HIGHLAND CITY DEVELOPMENT ADMINISTRATION BOARD AGENDA

DEVELOPMENT ADMINISTRATION BOARD AGENDA REPORT ITEM #2

DATE: April 11, 2024
TO: Development Administration Board
FROM: Rob Patterson, City Attorney / Planning & Zoning Administrator
SUBJECT: **Final Plat Approval:** Foxwood Estates
TYPE: **LAND USE (ADMINISTRATIVE)**

Foxwood Estates Subdivision

Date
4-2-2024
Scale
1" = 20'
By
TD
Tracing No.
L - 10816
Sheet No.
P - 12

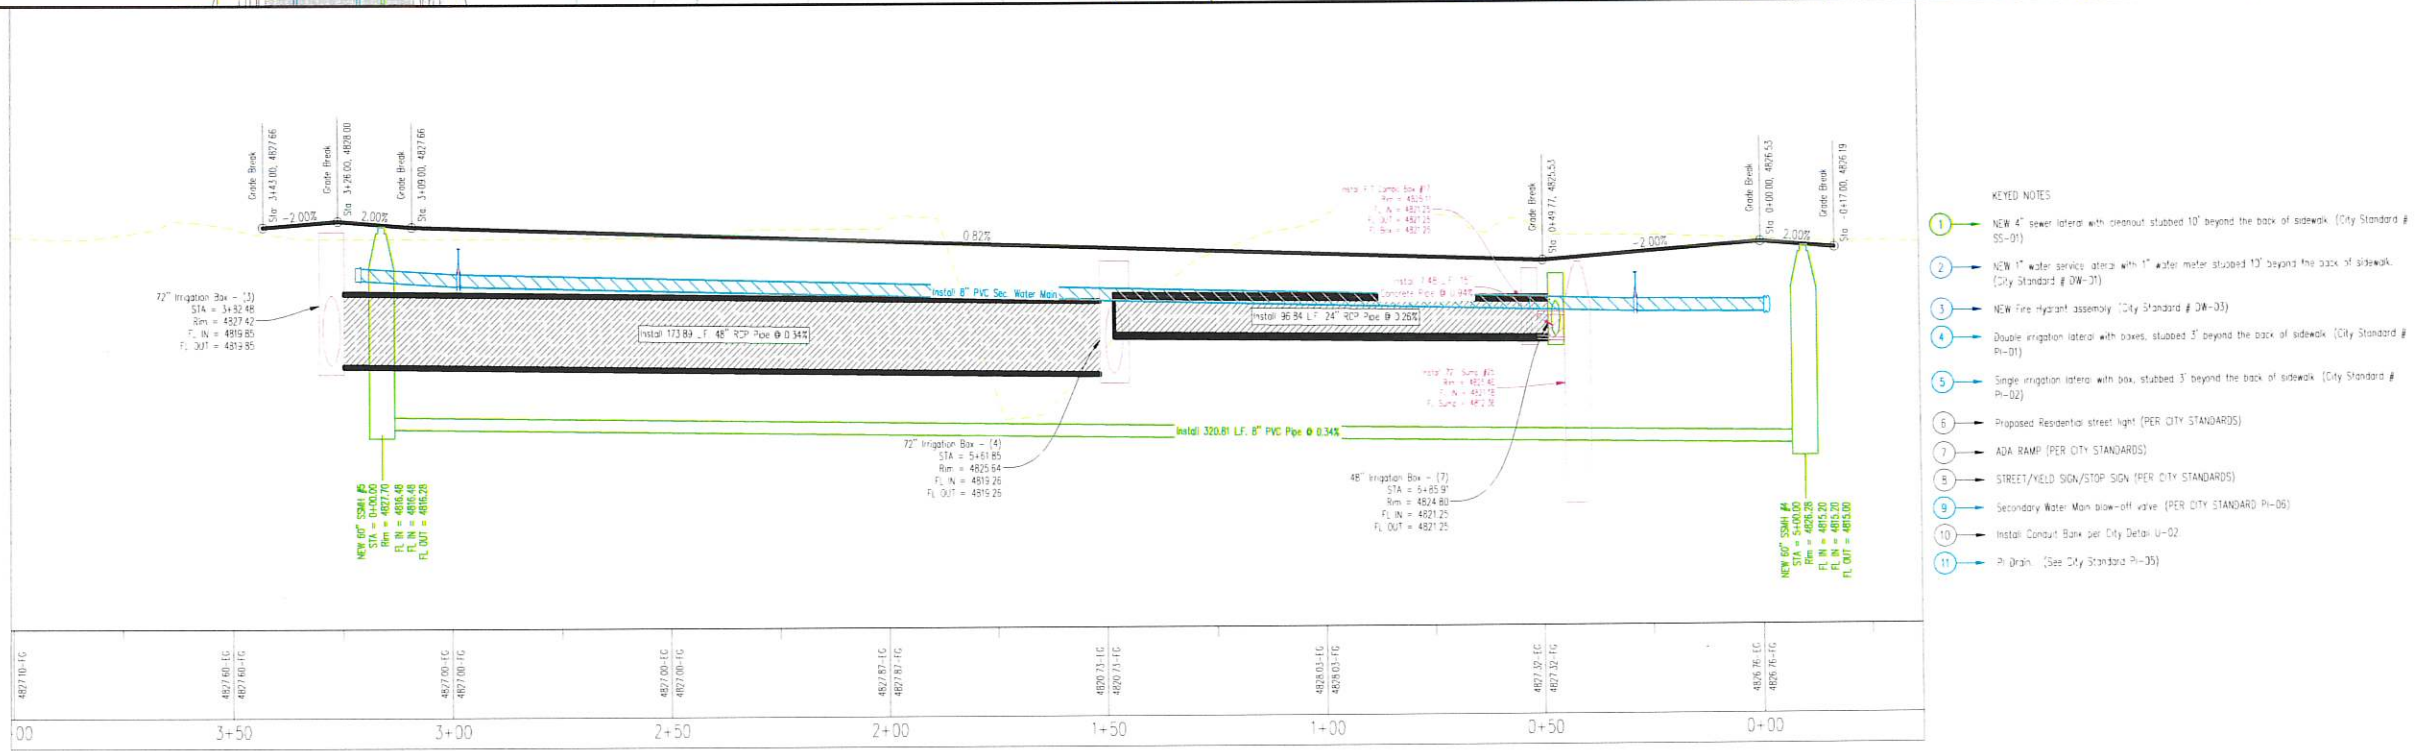
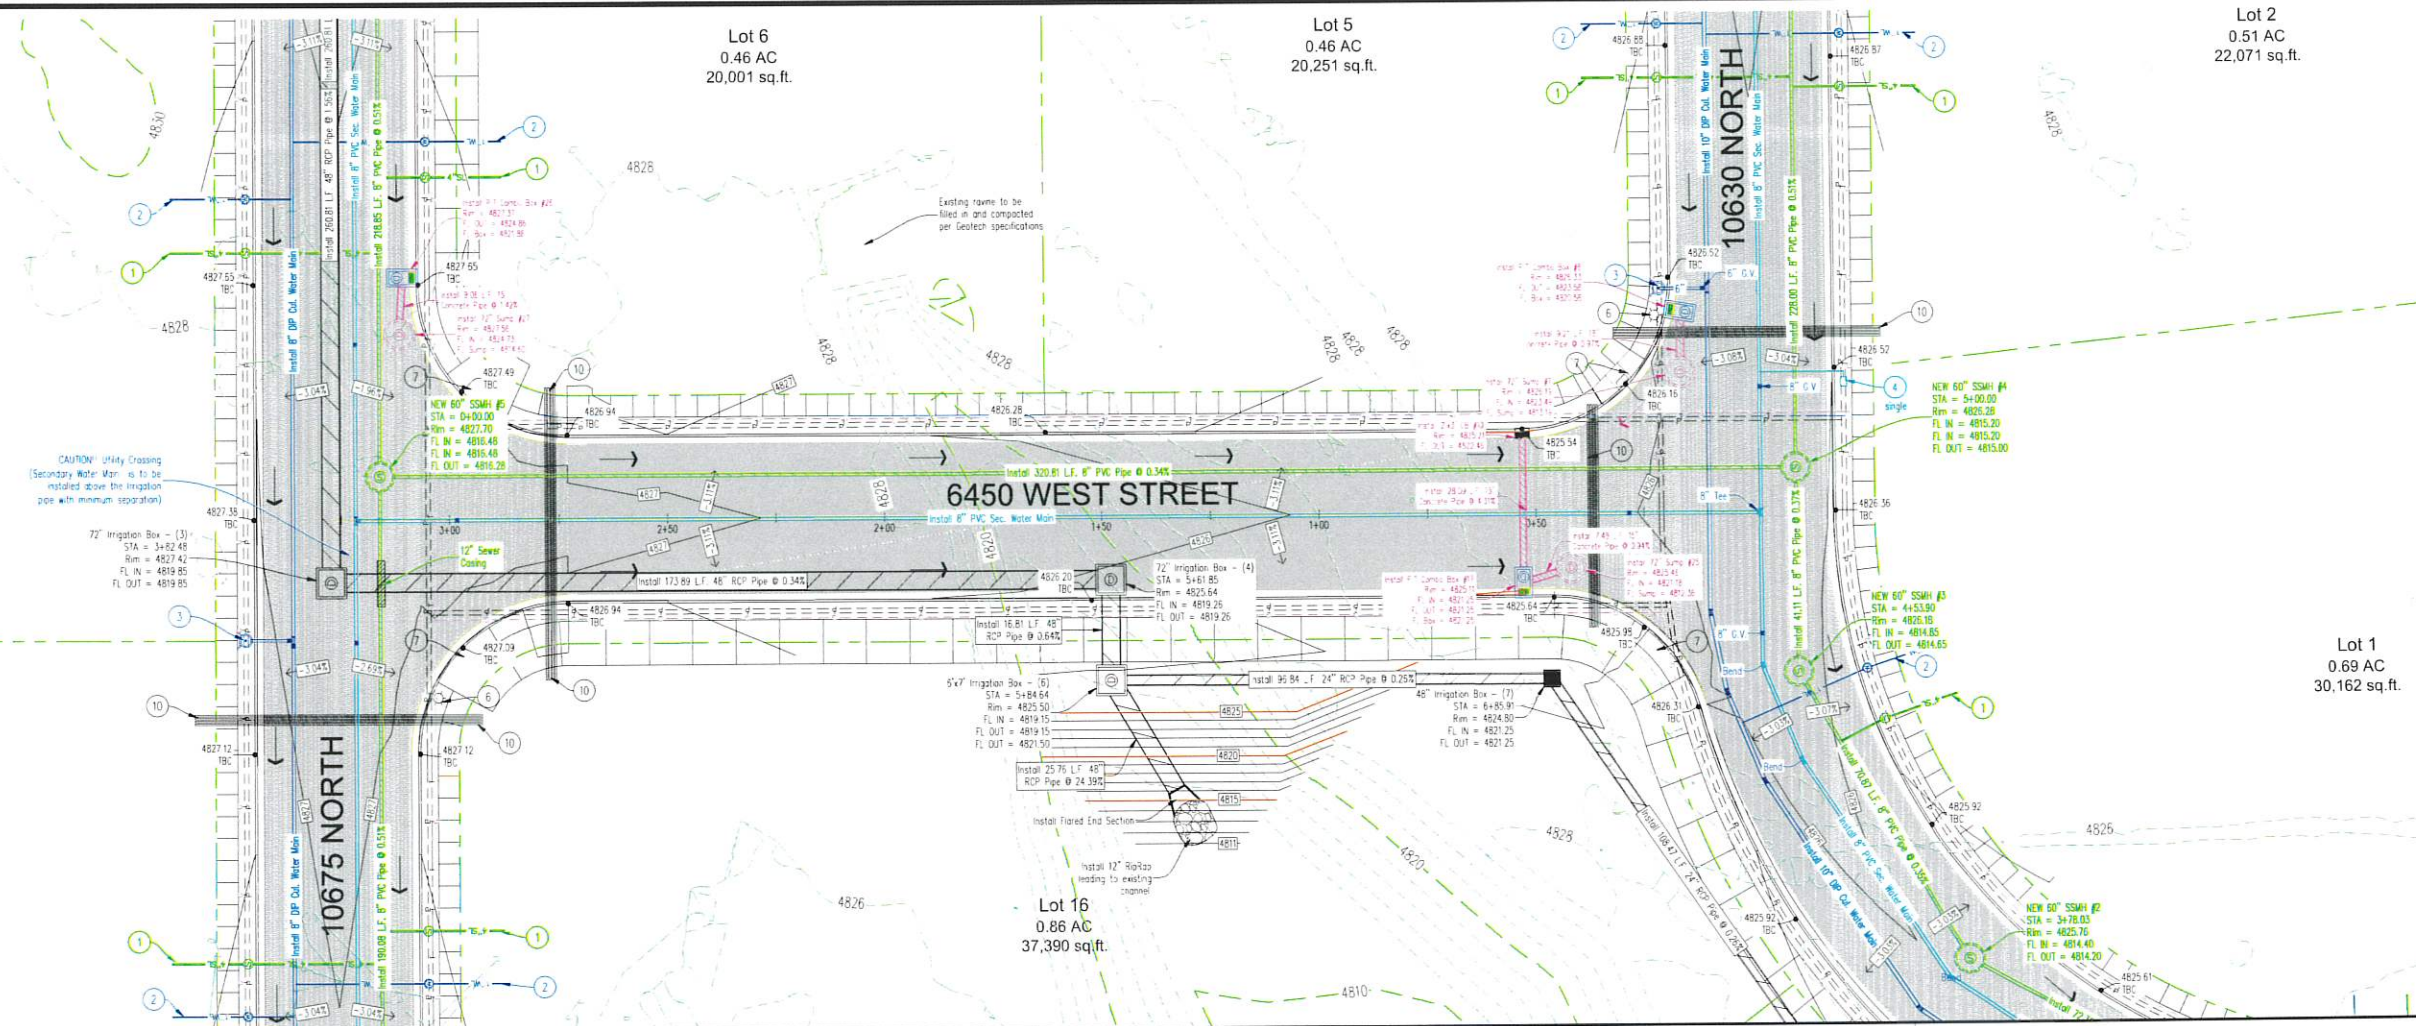
Sheet P-12:

Revisions	
Date	4-2-2024
Scale	1" = 20'
By	TD
Tracing No.	L - 10816
Sheet No.	P - 13

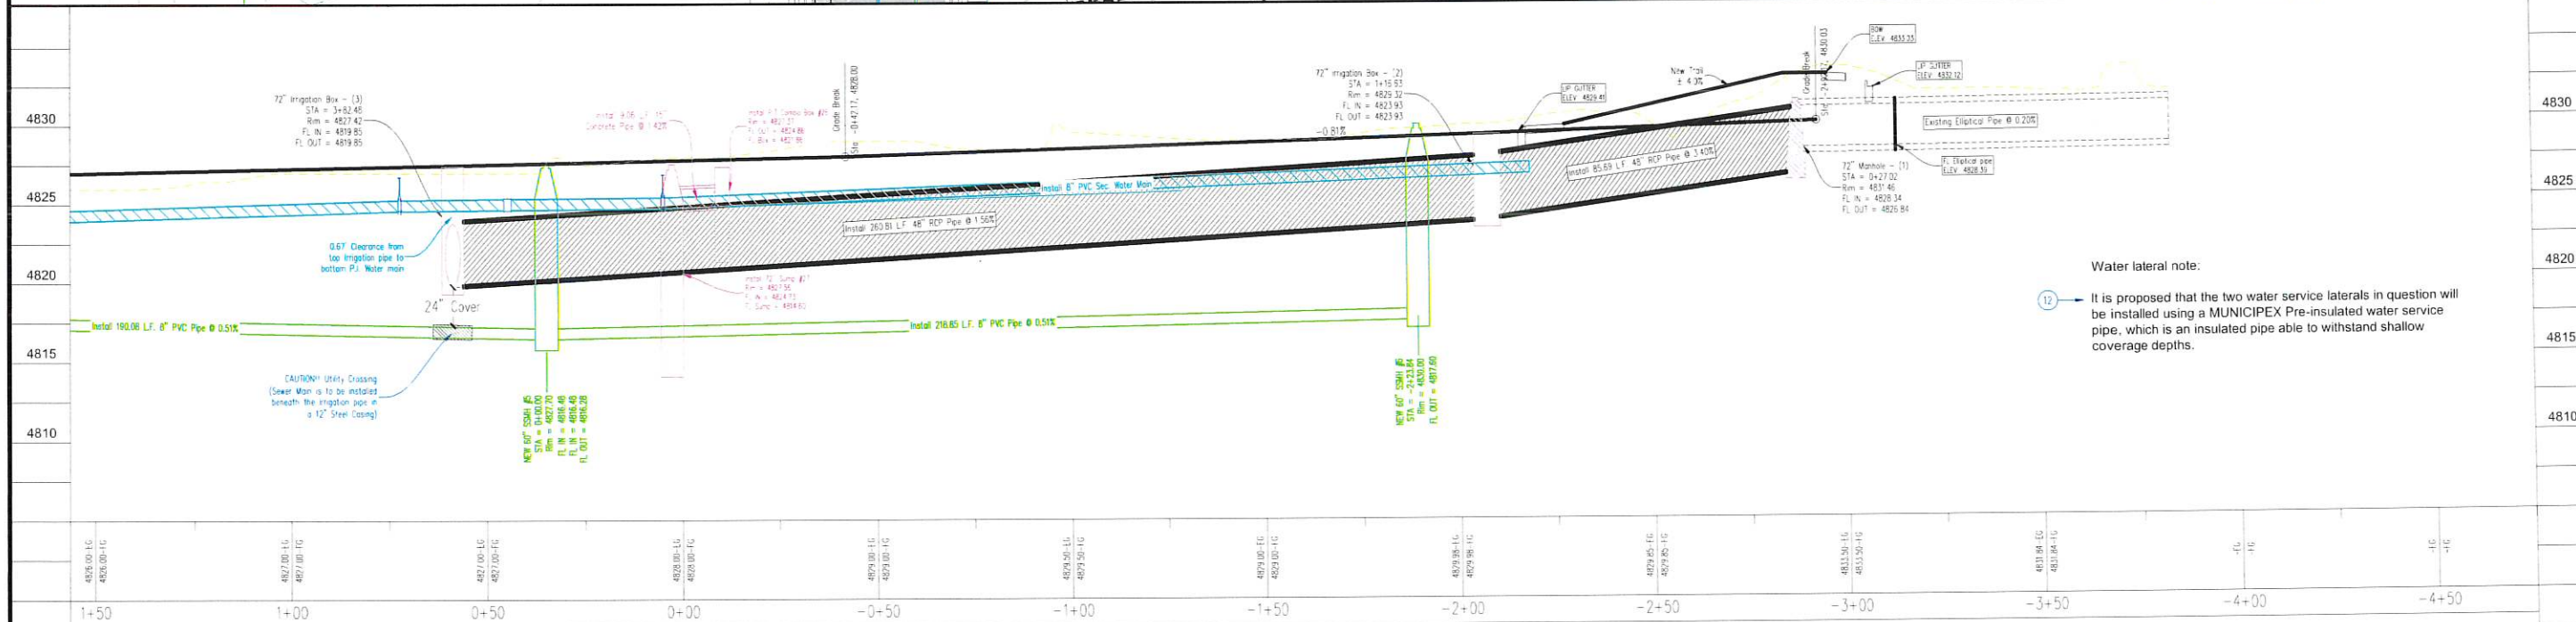
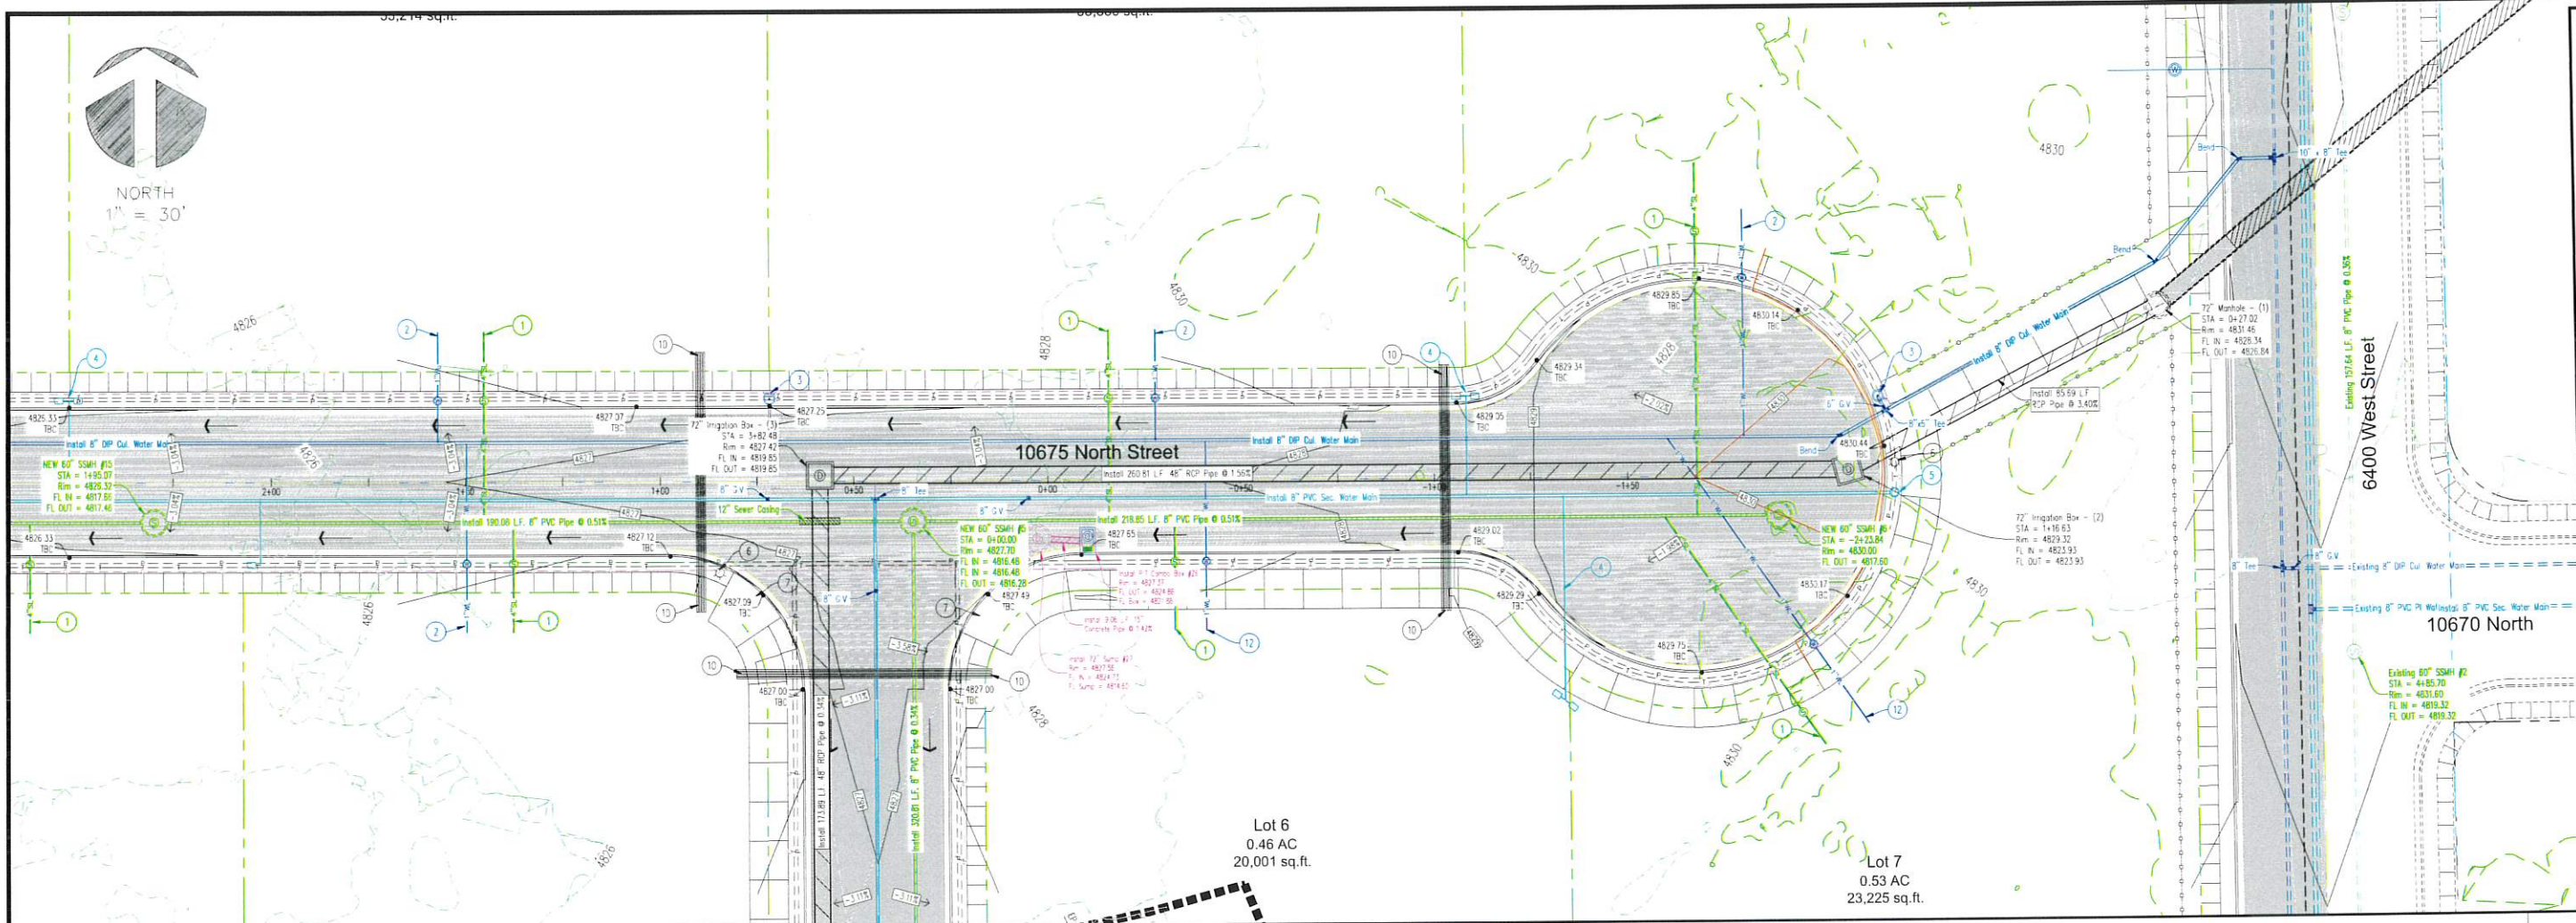
Sheet P-13:
